STATE OF CALIFORNIA
PUBLIC UTILITIES COMMISSION
505 VAN NESS AVENUE
SAN FRANCISCO, CA 94102-3298

SUBJECT: Commission Resolution SU-40 changes to General Orders 95 and
128

Resolution SU-40

RULES FOR OVERHEAD LINE CONSTRUCTION, GENERAL ORDER NO. 95 STATE
OF CALIFORNIA PUBLIC UTILITIES COMMISSION

(Existing)
Requirements for Supply Lines

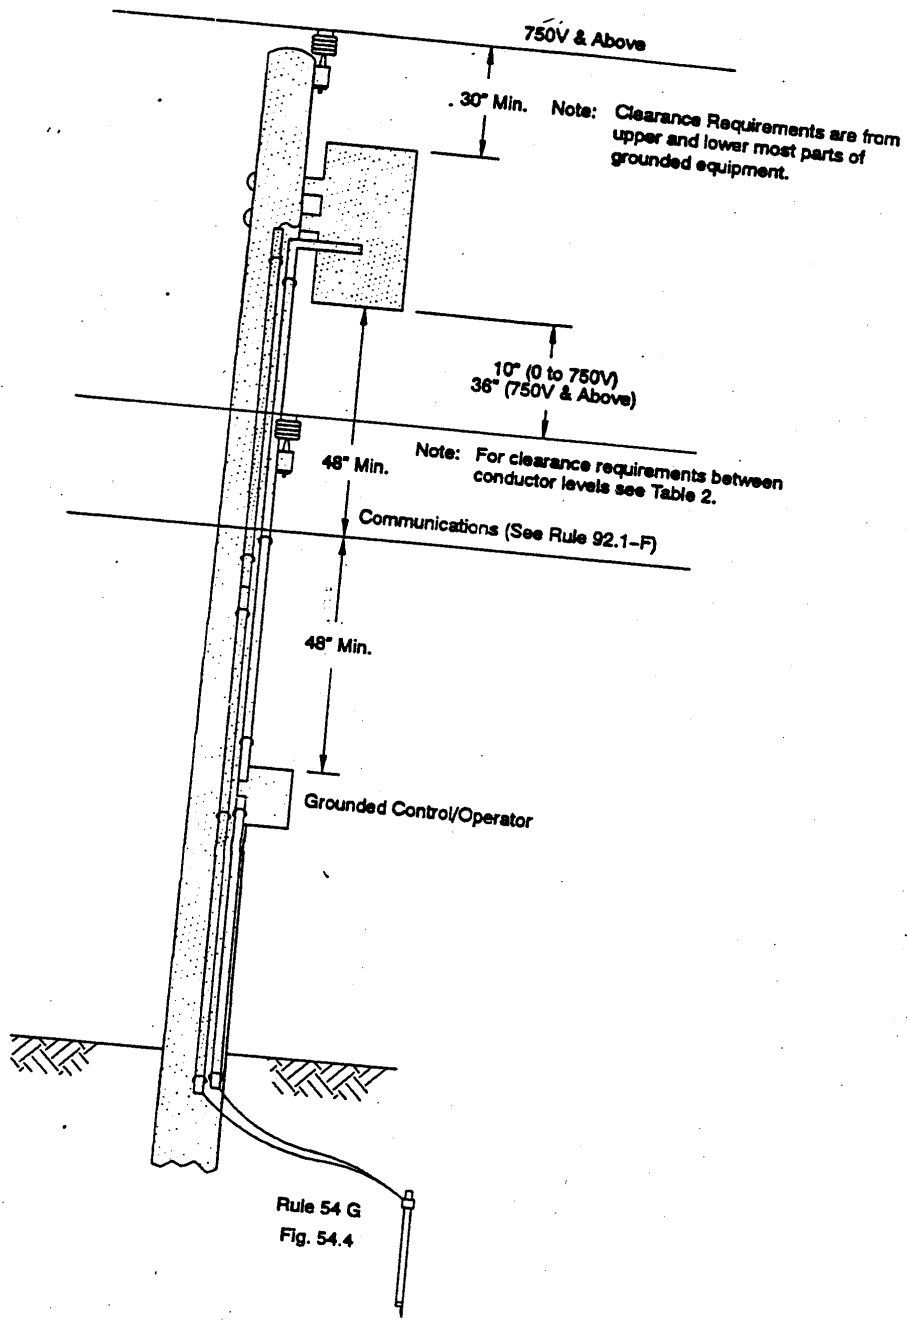
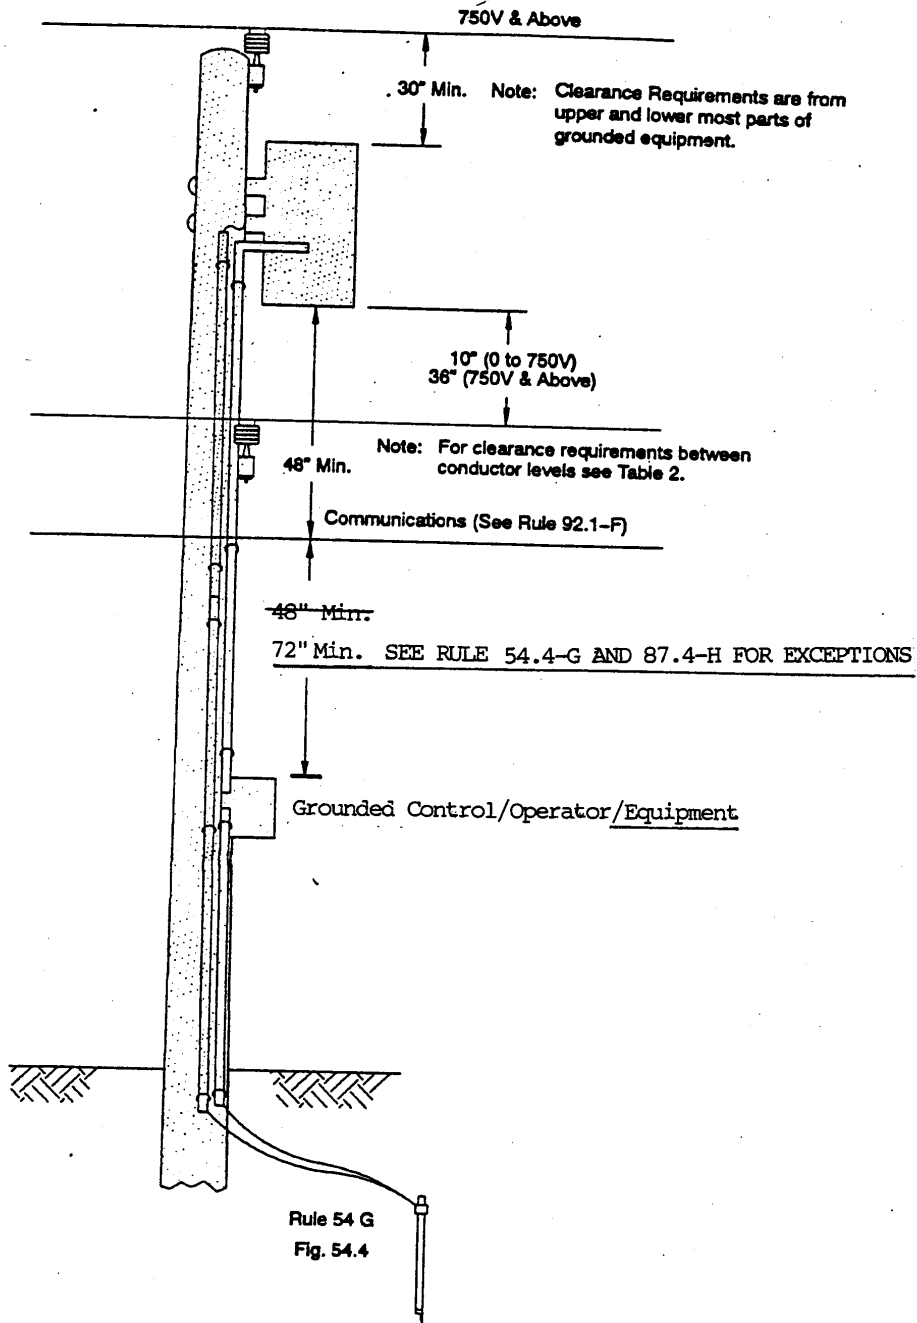
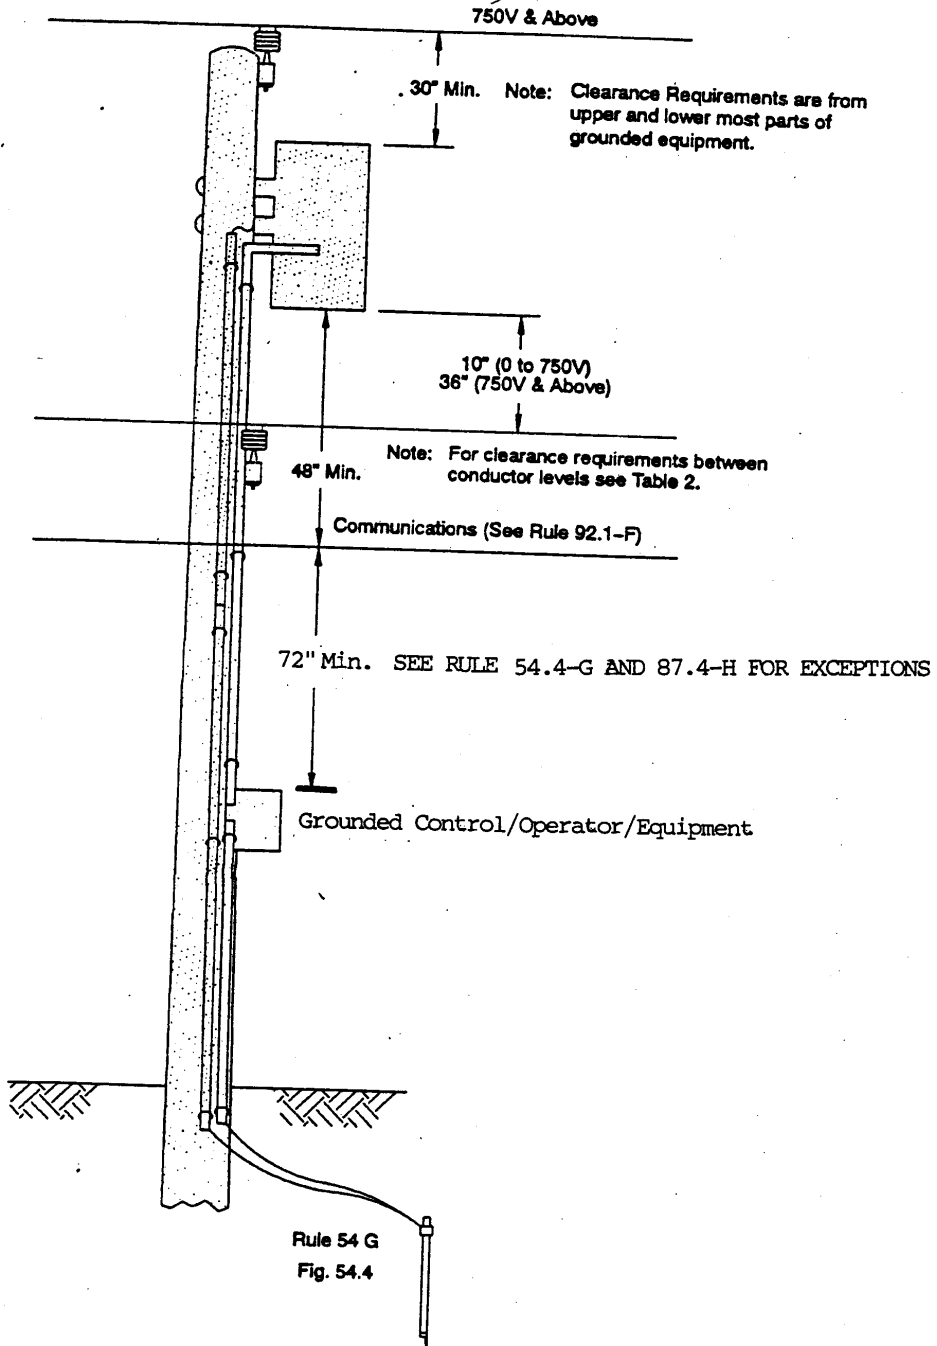
The present language addresses communication line conductors (open wire) but not cable and messenger which is the prevalent construction. This proposal will change communication line conductors to communication cable and messengers.

This proposal also modifies clearance between supply grounded metal boxes, hardware or metal cases for equipment placed below communication level, and communication owned cables and messengers.

All grounded metal boxes, hardware and metal cases for equipment, on non-metallic poles or non-metallic structures shall be a minimum of 36 inches above and 30 inches below the next level of unprotected conductors. Such equipment shall have a minimum clearance of 48 inches above or 72 inches below communication line conductors, cables and messengers of different ownership. See Figure 54-4.

FIGURE 54-5

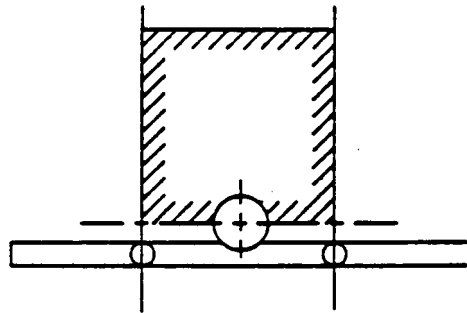
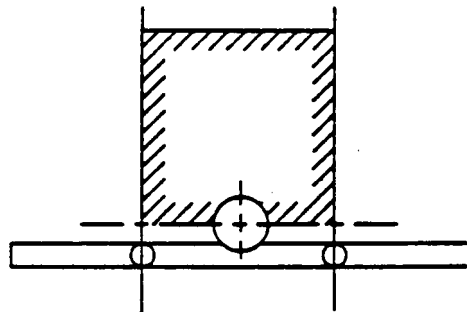
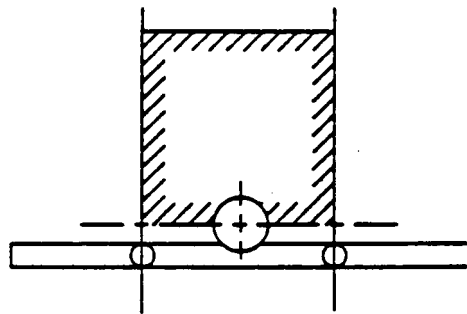
RATIONALE FOR PROPOSED G.O. 95 RULE CHANGE
Rule 54.7
Climbing and Working Space
And
ASSOCIATED RULE CHANGE
Rule 54.4-D8
Conductor - Clearance - At Top of Pole

This proposed rule change will help clarify the language of Rule 54.7. Minor changes in format have been made.

Lightning arresters have been added to allowable working space obstructions as they were inadvertently overlooked with the SU-5 change package. Removing the 6 foot clearance requirement and the exception in Rule 54.4-D8 removes an unnecessary requirement without affecting safety to workers or the general public.

(1) Dimensions Where Line Arms Only Are Involved: The climbing space where line arms without related buck arms are involved on poles or structures shall be on one side or face of the pole, with the center line of pole approximately midway on one side of the climbing space (See Figure 54-5), and shall have the following dimensions:

Figure 54-9

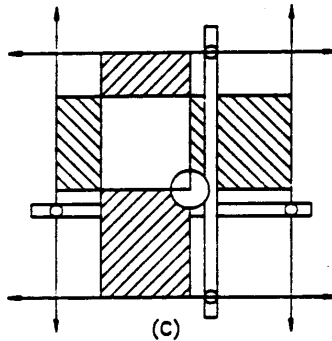
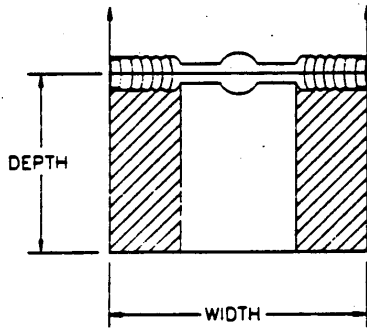
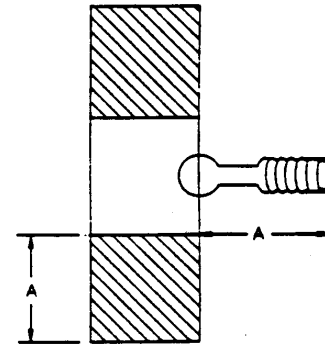
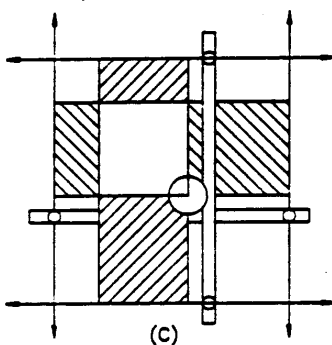
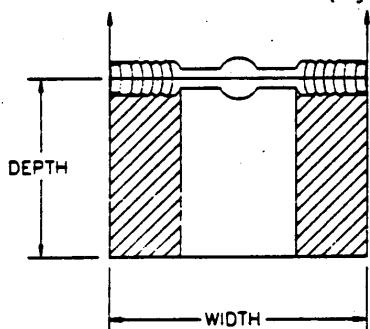
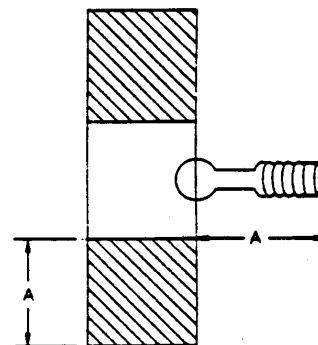
c. Cutouts, disconnects, switches, lightning arresters and their leads may be installed in the working space (but not in the climbing space).

e. The width of the working space of supply circuits above 750 volts where wood crossarms are not involved (e.g., vertical and triangular construction without wood crossarms) shall extend from the climbing space to the outmost conductor position on the conductor support involved. The depth of the working space shall have the same dimension as the climbing space and shall be measured from the centerline of pole (See Figure 54-9D and 54-9H). When conductors above 750 volts are located on one side of the pole only (e.g., vertical construction), the dimensions of working space shall be applied as illustrated in Figures 54-9E and

54-9F (dimension "A" is equal to the distance from the climbing space to the outmost conductor position). When climbing space is located in a quadrant, working space shall be applied as illustrated in Figure 54-9G.

Fig. 54-21

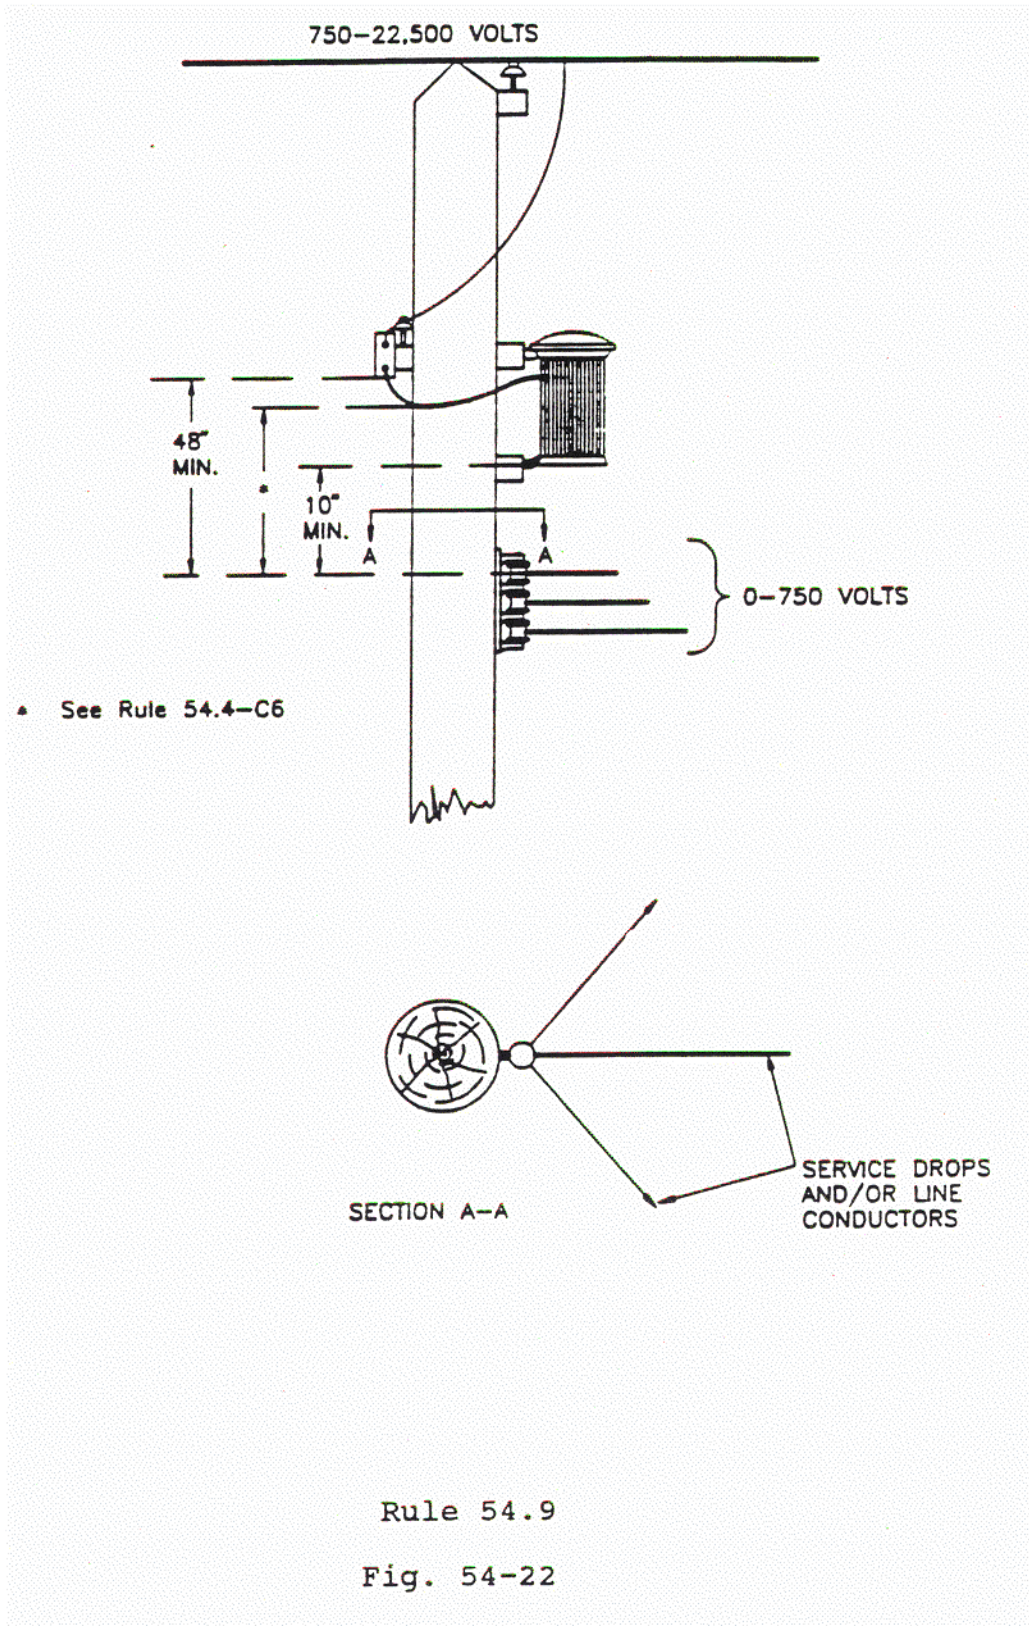
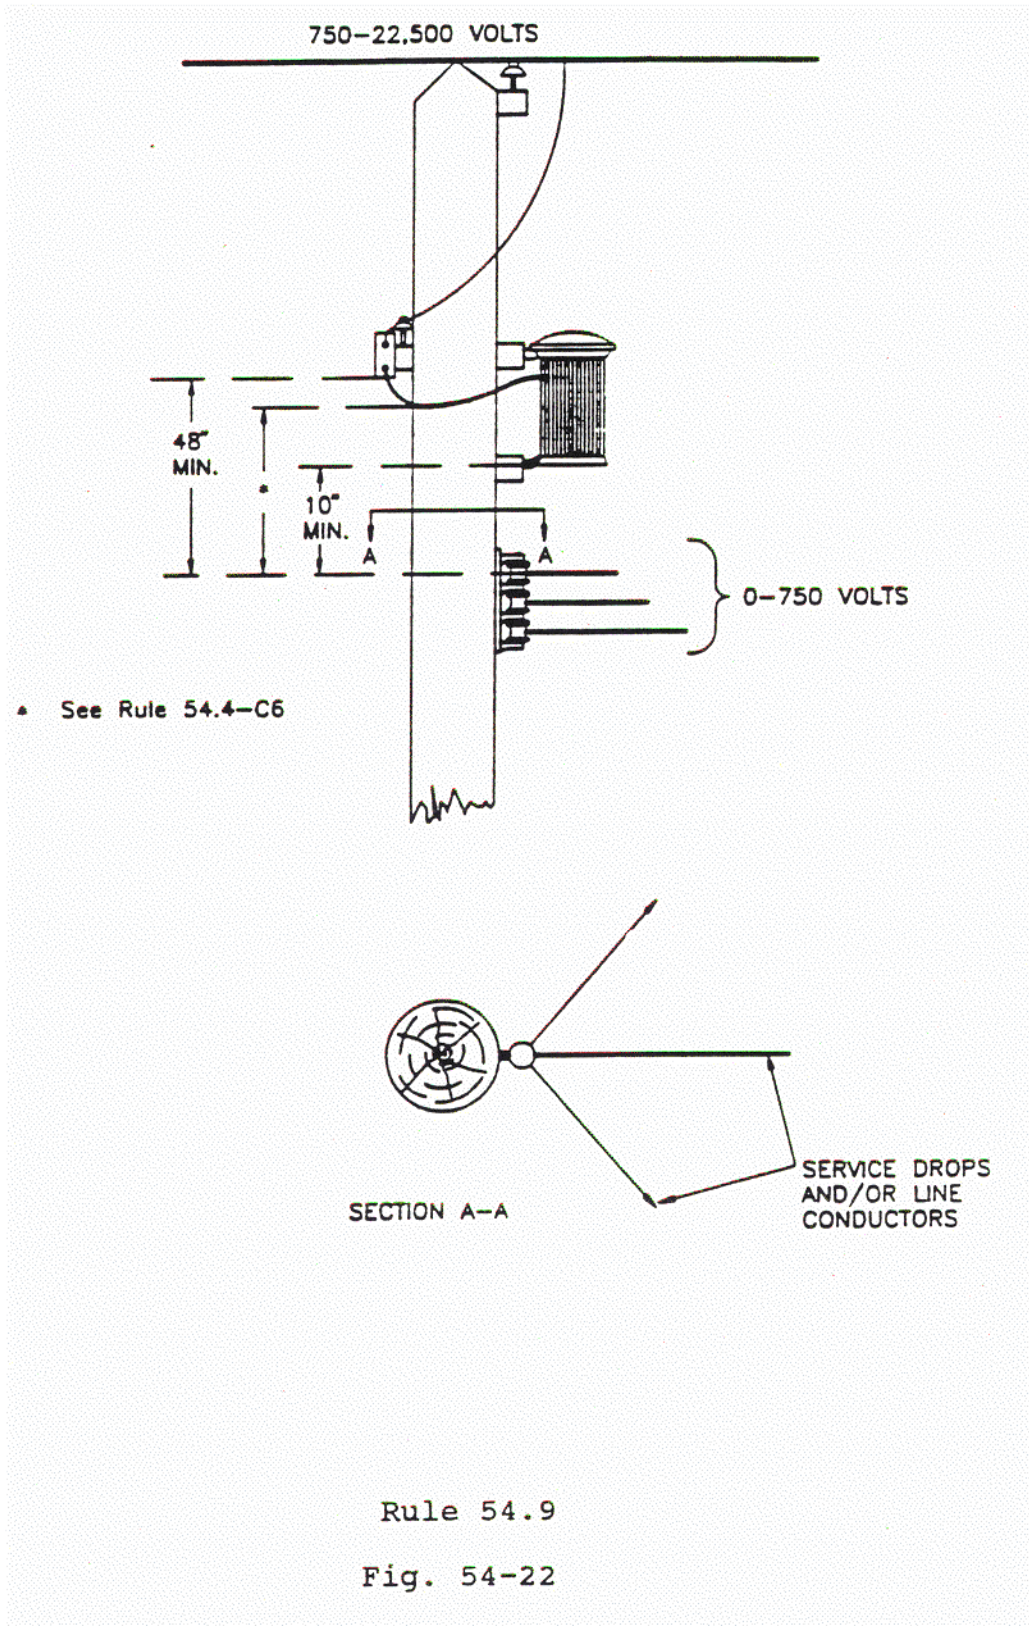
~~(32) Conductors Deadended Under a Equipment transformer: No guard arm will be required over line or service drop conductors attached in rack configuration construction deadended to on the surface of a pole directly below equipment (e.g., transformer, capacitor and other similar apparatus). Such conductors shall have a vertical clearance of not less than: a transformer installation provided that at that level all attachments to the pole shall be approximately in the vertical plane through the center lines of pole and transformer installation and no conductor so attached makes an angle greater than 60 degrees with that plane. The top conductor so supported shall have a vertical clearance of not less than 48 inches below the level of conductors on the hanger arm; a vertical clearance not less than as specified in Rule 54.4-C6 below the lowest point of the drip loop of primary leads to the transformer; and a vertical clearance of not less than 10 inches below the lowest part of the transformer case or hangers (see App. G, Fig. 33).~~

- ~~(a) 4 feet below unprotected conductors: and~~
- ~~(b) As specified in Rule 54.4-C6 below the lowest point of drip loop of the primary leads to the transformer(s): and~~
- ~~(c) 10 inches below the lowest part of the equipment case(s) or hangers(s)~~

(c) 10 inches below the lowest part of the equipment case(s) or hangers(s)
